**ENVIRONMENTAL ASSESSMENT REPORT**

**Name of Applicant:** Cameron LNG, LLC (Cameron)

**Docket No:** CP15-560-000

# **Cameron LNG Expansion Project**

**Figure 3:** Location of the Momentum Barrier.

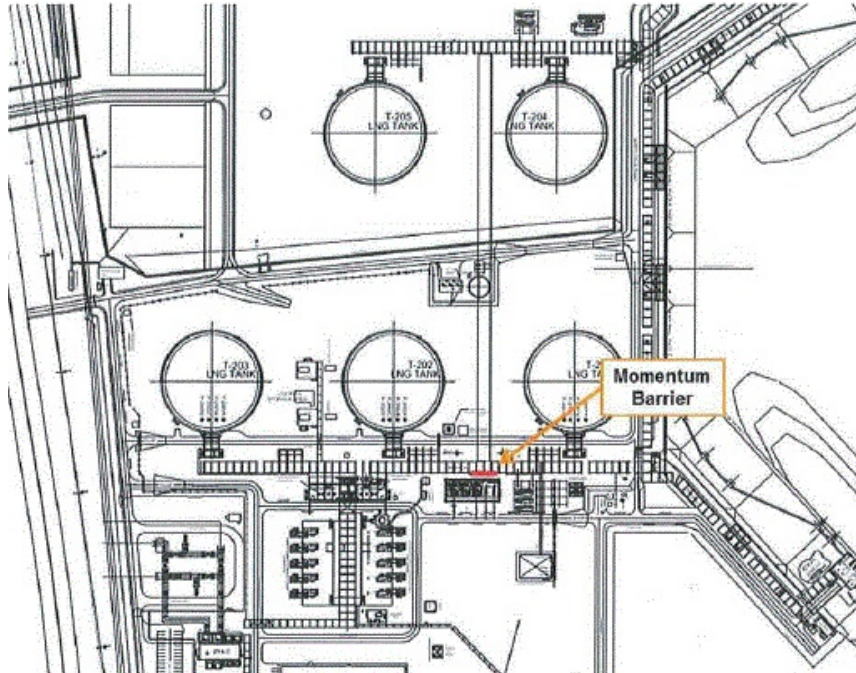
Scenario 3 in table 2.7-4 shows the 2-inch hole release from the 30-inch-diameter sendout header. Cameron LNG proposed to install a jet-momentum barrier located 18 feet downstream of the potential release location in order to break up the momentum of the LNG jet from this release. The barrier would be attached to the pipe rack structure and would be 8.9 feet above ground level. The barrier would measure 46 feet wide and 26 feet tall. Figure 3 shows the location of the momentum barrier. In order to ensure that the jet-momentum barrier is maintained throughout the life of the facility, **we recommend that:**

- Prior to construction of the final design, Cameron LNG should file with the Secretary for review and written approval by the Director of OEP the procedures to maintain and inspect the barriers provided to meet the siting provisions of 49 CFR 193.2059. This information should be filed a minimum of 30 days before approval to proceed is requested.**

**Figure 6:** Flammable Vapor Exclusion for 2-inch Hole Release from the In-tank Pump Discharge Piping (Scenario 2).

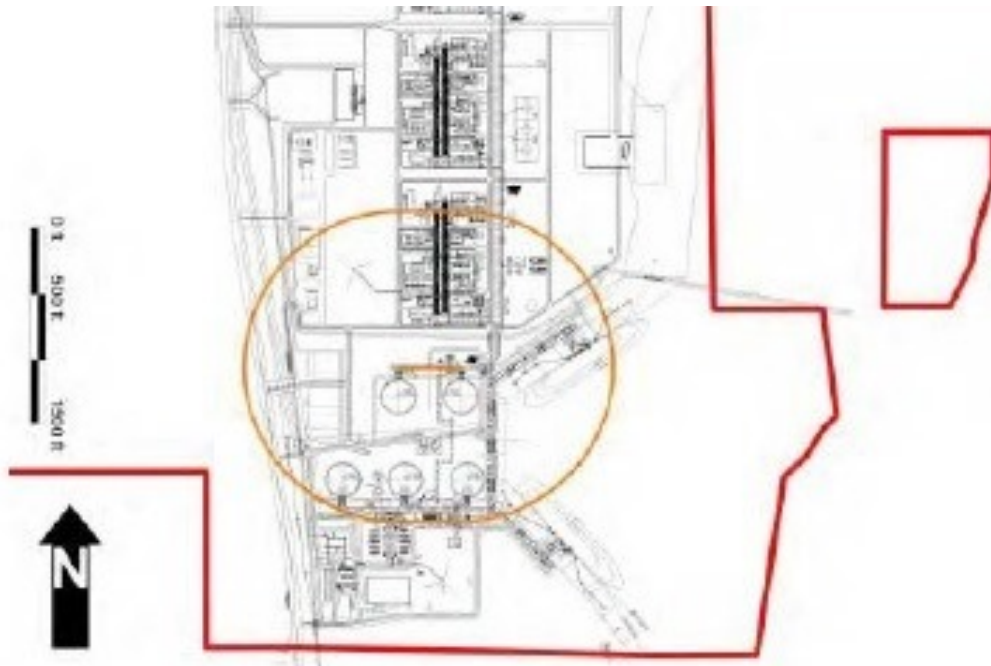
Figures 6 and 7 “Vapor Dispersion Design Spill Analyses for LNG” show the flammable vapor cloud from releases at the 30-inch diameter sendout- header would migrate under the LNG storage tanks. On December 16, 2015, Cameron LNG stated that the LNG storage tank will be designed to withstand the effects of overpressure from ignition of the vapor cloud under the tank. If necessary, measures will be included to mitigate the effect of potential blast overpressures, including measures to prevent flammable vapors from entering the space below the tank. Therefore, **we recommend that:**

**Figure 13:** Flammable Vapor Exclusion Zone from for a 4-inch Mixed Refrigerant Release (Scenario 1).

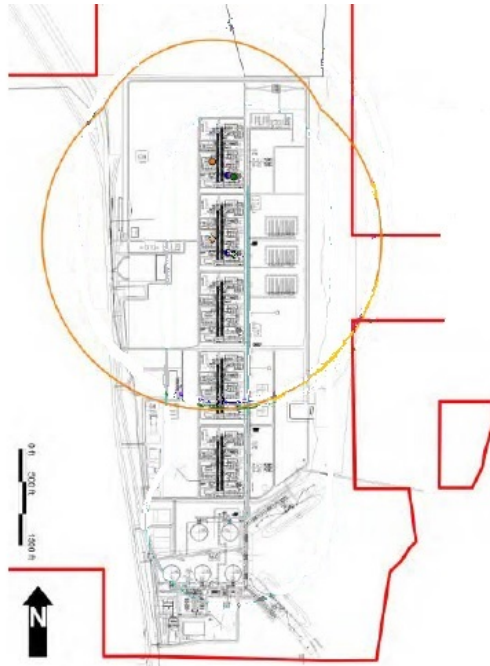
Figure 13 shows the vapor dispersion from the mixed refrigerant release would extend over the Calcasieu Ship Channel. In this case, the DOT has not objected to the flammable vapor dispersion hazards extending over a navigable waterway. The distances to the ½-LFL vapor cloud for all propane and heavy hydrocarbon release scenarios would remain within the Cameron LNG property. We conclude that the siting of the proposed project would not have a significant impact on public safety. If the facility is constructed and operated, compliance with the requirements of 49 CFR 193 would be addressed as part of DOT's inspection and enforcement program.

**Figure 18:** Distance to the Hazardous Atmosphere for a 3-inch Liquid Nitrogen Release from the Liquid Nitrogen Storage Area

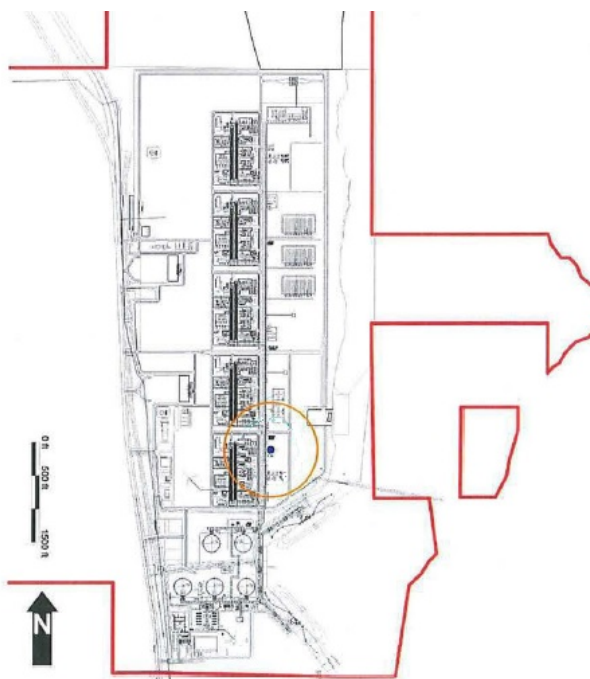
The PHAST results indicate the endpoint distance of 705 feet, and Figure 18 indicate that the nitrogen vapor would remain within Cameron LNG's property. As a result, we conclude that the siting of the proposed project would not present a significant impact to the public with respect to asphyxiate hazards. If the facility is constructed and operated, compliance with the requirements of 49 CFR 193 would be addressed as part of DOT's inspection and enforcement program. Cameron LNG also proposes to consult with the nitrogen system supplier regarding safe practices and design. In order to limit the risk of asphyxiate hazards, we recommend that:

**Figure 19:** Vapor Cloud Explosion of Mixed Refrigerant at Liquefaction Trains

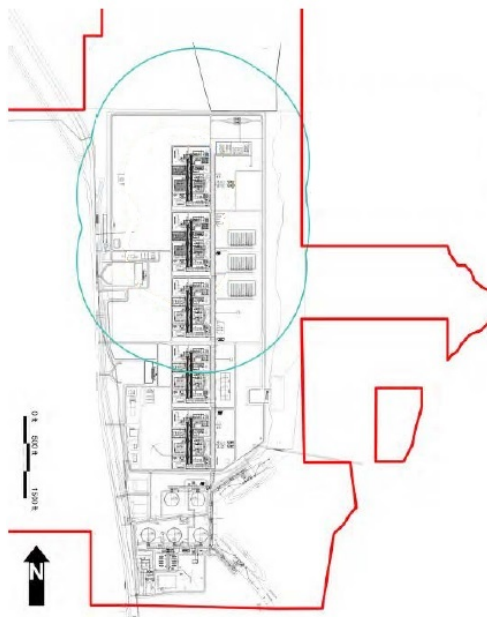
Figure 19 shows that the overpressure from mixed refrigerant vapor cloud explosion would extend over the new firewater tank, refrigerant storage area, and trucking area. Cameron LNG also proposes evaluate the effect of vapor cloud explosions on fire protection equipment and occupied buildings during the detailed design phase. Therefore, **we recommend that:**

Figure 19 also shows the 1-psi overpressure would extend over Cameron LNG's property into the water channel. In this case, the DOT has not objected to the 1-psi overpressure due to vapor cloud explosion extending over a navigable waterway. Based on Cameron LNG's overpressure analysis and our recommendations, we conclude that the siting of the proposed project would not have a significant impact on public safety due to vapor cloud explosion events. If the facility is constructed and operated, compliance with the requirements of 49 CFR 193 would be addressed as part of DOT's inspection and enforcement program.

**Figure 21:** Thermal Radiation Exclusion Zones

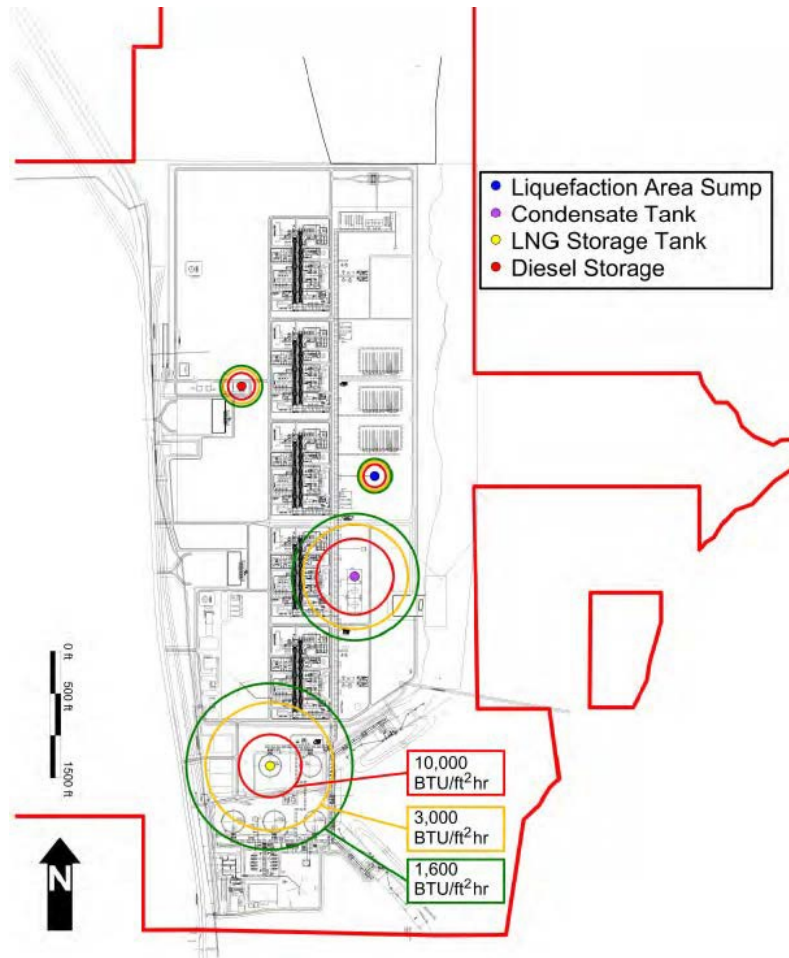
The 10,000-, 3,000-, and 1,600-Btu/ft<sup>2</sup>-hr heat fluxes from the LNG storage tank and the 1,600-Btu/ft<sup>2</sup>-hr heat flux from the LNG storage tank, the new Liquefaction Train Impoundment, the stabilized condensate storage tank dike, and diesel tank dike would remain within the facility property lines. Cameron LNG also evaluated jet fires from the design spills using PHAST version 6.7. The results showed that the jet fire radiant heat to 1,600 BTU/ft<sup>2</sup>-hr for the design spills would remain within the Cameron LNG property. As Cameron LNG's calculations show the radiant heat limits for pool fire and jet fire scenarios would stay within Cameron LNG property, we conclude that the siting of the proposed project would not have a significant impact on public safety with regard to thermal radiation from fires. If the facility is constructed and operated, compliance with the requirements of 49 CFR 193 would be addressed as part of DOT's inspection and enforcement program.
